To: T10 Technical Committee
From: SDV working group via Bill Ham (Bill.Ham@Compaq.com)
and Rob Elliott, Compaq Computer Corporation (Robert.Elliott@compaq.com)
Date: 27 July 2001
Subject: T10/01-149r0 SDV working group recommendations for changes to SPI-4

This document contains the recommendations of the SDV working group for changes to SPI-4 regarding the margin control mode page and ECP page and to define "driver-receiver connection" in the model.

Figure 1 - Device to device driver-receiver connections

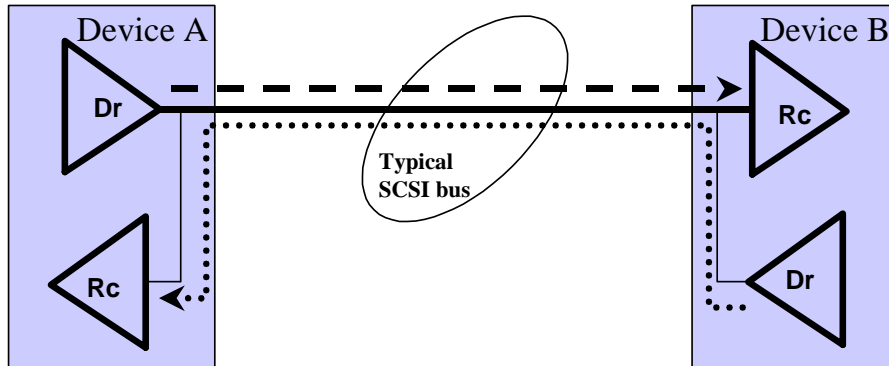
[add this text as a new section:]

4.x Driver-receiver connections

Figure 1 [shows a portion of a single SCSI bus segment between two SCSI devices. Each device has a driver and a receiver for each signal. There may be other SCSI devices or terminators not shown in Figure 1 that are connected to the path between the driver and the receiver. Two driver-receiver connections exist between any two SCSI devices or simple expanders, one for each direction.](#)
